APPENDIX 7.5: Leakproof Insert Pre-shipment Leak Test

EVALUATION OF LPI MODIFICATIONS

Figure 1: Modified F-320 Leakproof insert, Assembled

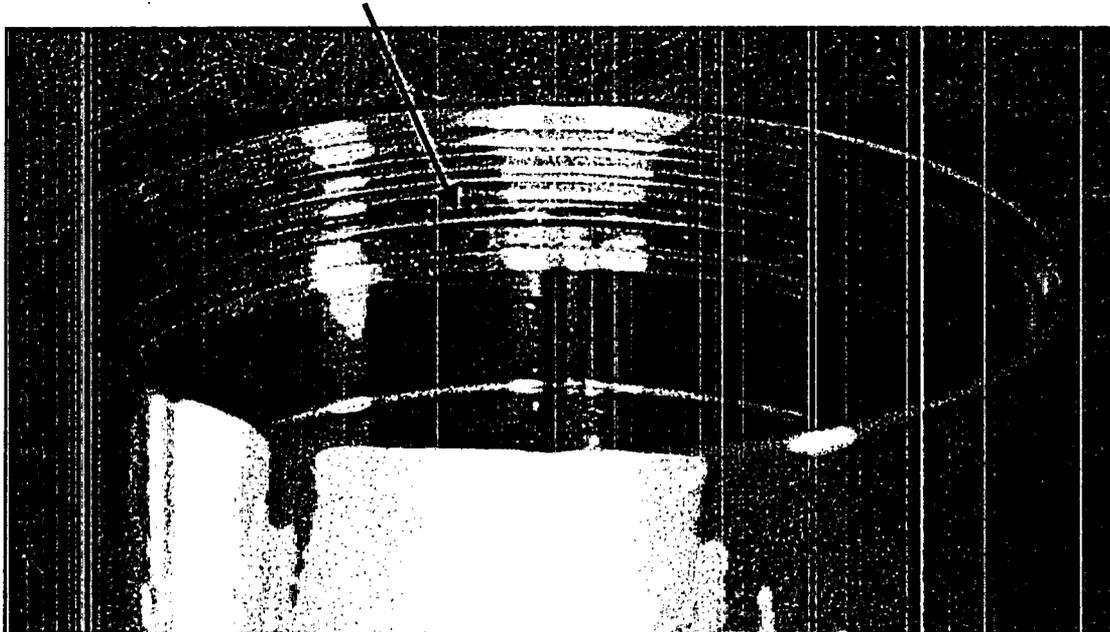
In Figure 1, the F-320 leakproof insert is shown assembled. The appearance is identical to an unmodified leakproof insert, with exception of the small test port visible. The cap is fully installed and there is no visible gap between the cap and the body. The assembly procedure and post-assembly visual inspection steps do not change.

Figure 2: Modified F-320 Leakproof insert Body, with Test Port hole

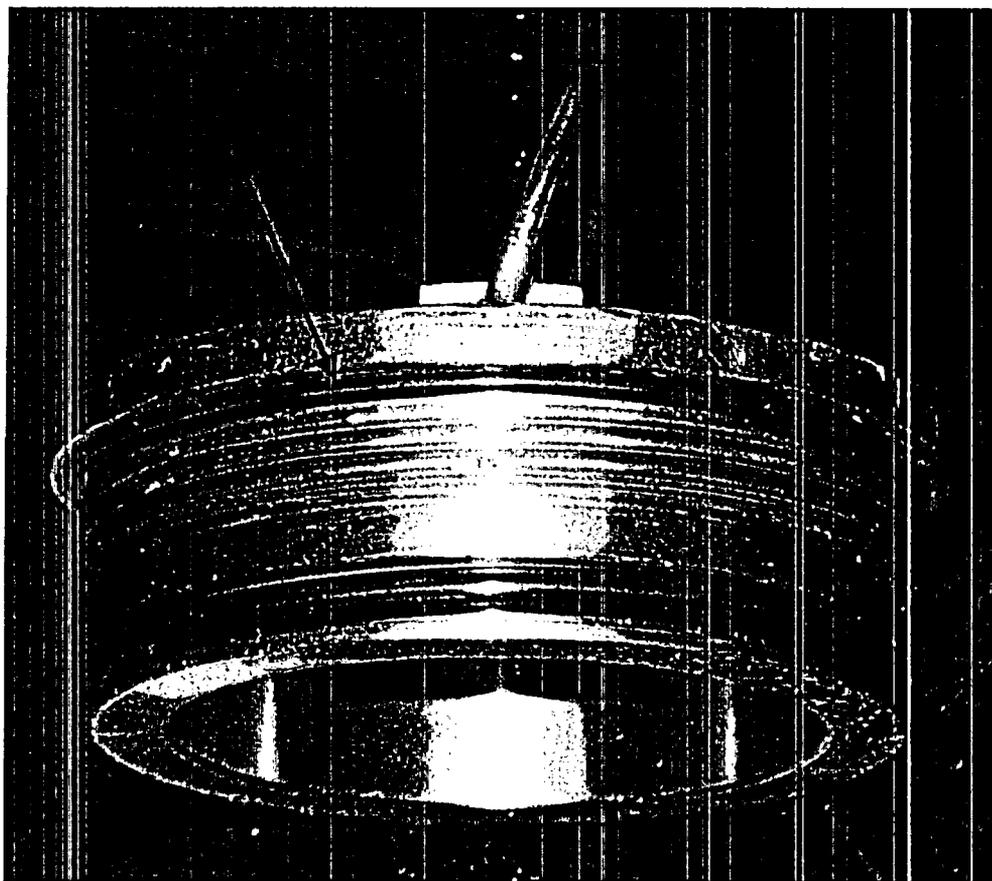
In Figure 2, the F-320 body is shown with the test port drilled between the threads and the sealing surface. In the design of all leakproof inserts, there is an undercut in the body in this location which permits a hole to be added that affects neither the threads or the sealing surface. In this way, the added test port does not affect the structural integrity of the threaded portion of the body, nor the containment boundary of the sealing surface. The dimensional tolerances of the upper rim of the body are adjusted to ensure a satisfactory compression of the added o-ring and a smooth mating surface for the added o-ring.
